August 17, 2006

ULNRC-05322

**DOCKET NUMBER 50-483
CALLAWAY PLANT
UNION ELECTRIC CO.
APPLICATION FOR AMENDMENT TO
FACILITY OPERATING LICENSE NPF-30
RELOCATION OF TECHNICAL SPECIFICATION CYCLE-SPECIFIC
PARAMETERS TO THE CORE OPERATING LIMITS REPORT
ADOPTION OF INDUSTRY TRAVELERS TSTF-339 AND TSTF-363**

Figure 2.1.1-1 (page 1 of 1)
Reactor Core Safety Limits

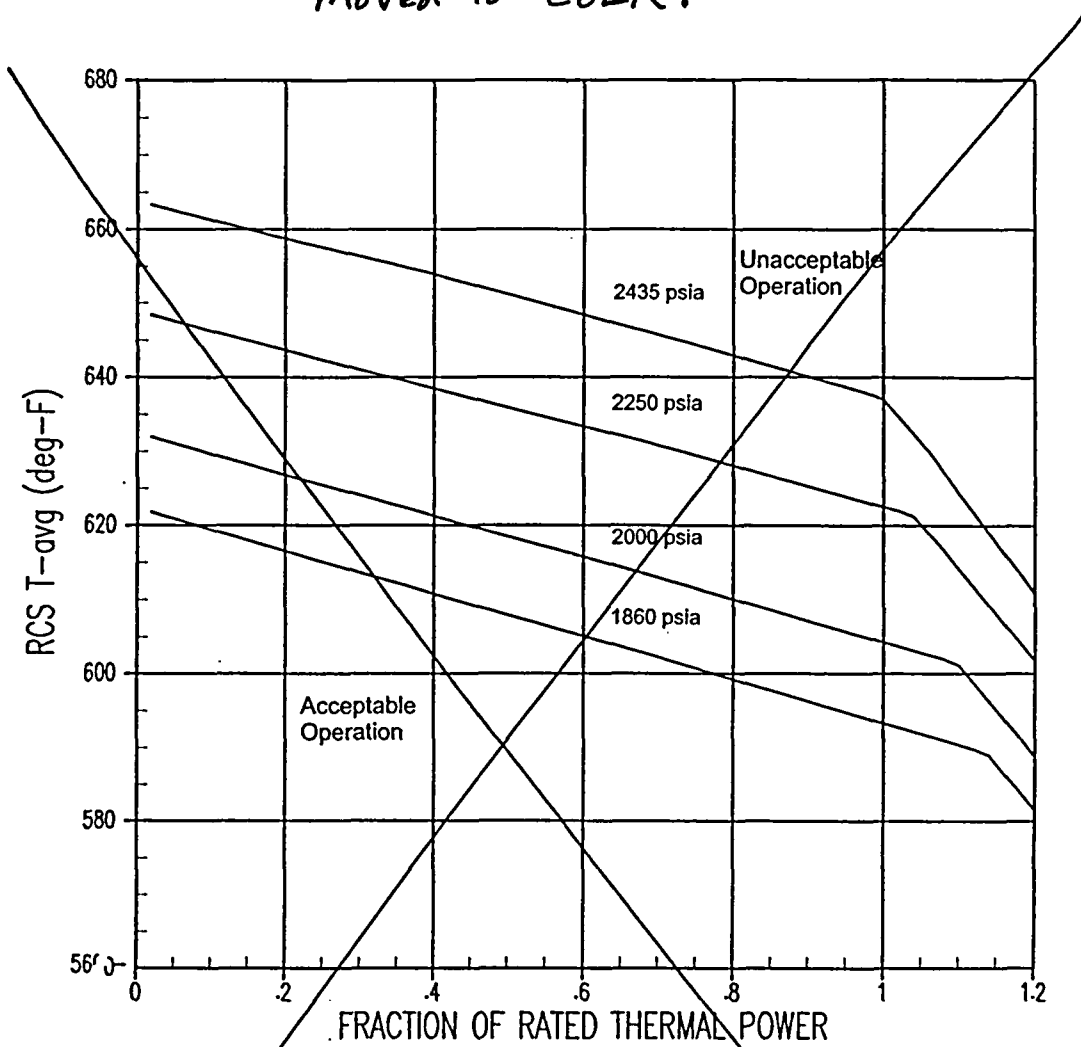
TS Figure 2.1.1-1, "Reactor Core Safety Limits," will be relocated to the COLR. In addition, TS 2.1.1 will be revised to read: "...shall not exceed the limits specified in the COLR; and the following SLs shall not be exceeded:

In MODES 1 and 2, the combination of THERMAL POWER, Reactor Coolant System (RCS) highest loop average temperature, and pressurizer pressure shall not exceed the ~~SLs~~ specified in ~~Figure 2.1.1.1.~~ *INSERT A*

Deleted from TS;
moved to COLR.

- 2.1.1.1 The design limit departure from nucleate boiling ratio (DNBR) shall be maintained ≥ 1.22 for transients analyzed using the revised thermal design procedure (RTDP) methodology and the WRB-2 DNB correlation. For non-RTDP transients analyzed using the standard thermal design procedure, the DNBR shall be maintained greater than or equal to the applicable DNB correlation limit (≥ 1.17 for WRB-2, ≥ 1.30 for W-3).
- 2.1.1.2 The peak fuel centerline temperature shall be maintained $< 5080^{\circ}\text{F}$, decreasing by 58°F per 10,000 MWd/MTU of burnup.

Figure 5

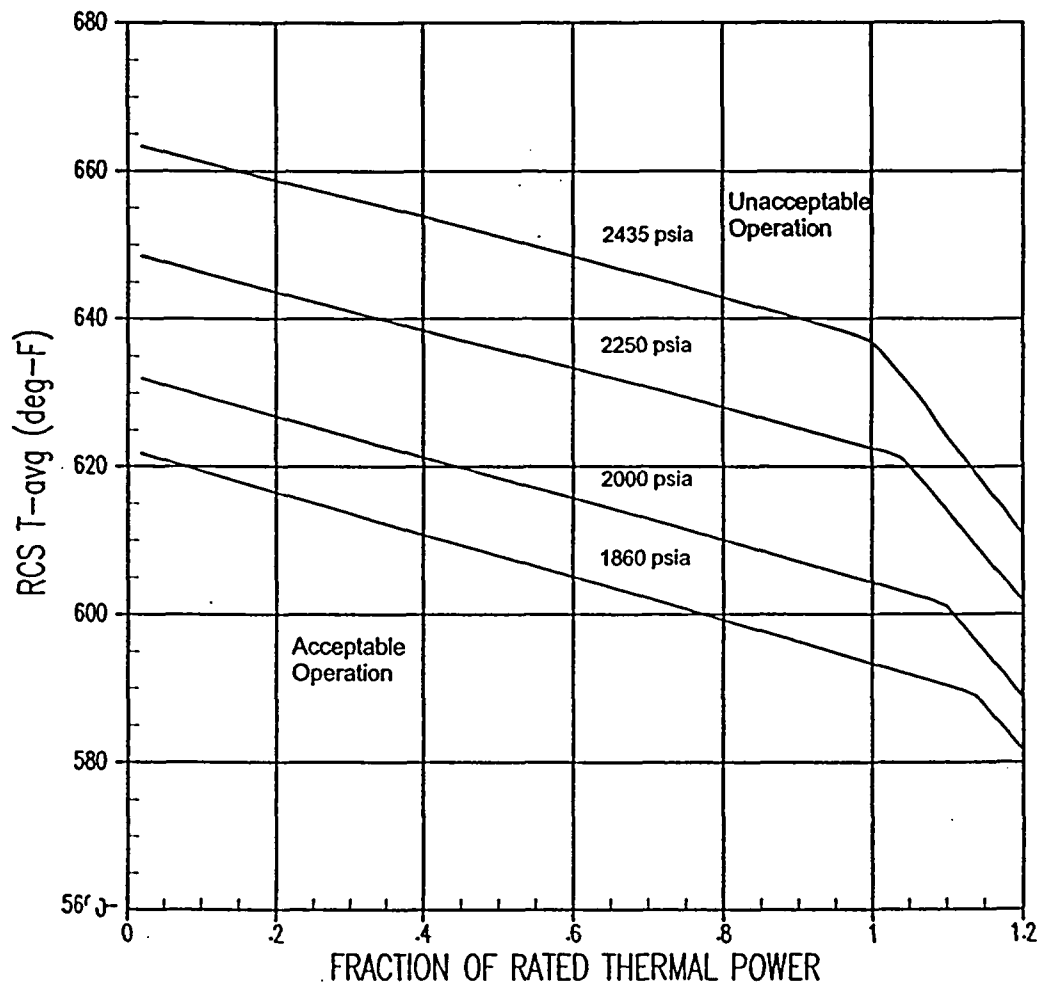
In MODES 1 and 2, the combination of THERMAL POWER, Reactor Coolant System (RCS) highest loop average temperature, and pressurizer pressure shall not exceed the limits in Figure 5.

~~Figure 2.1.1.1 (page 1 of 1)~~
Reactor Core Safety Limits
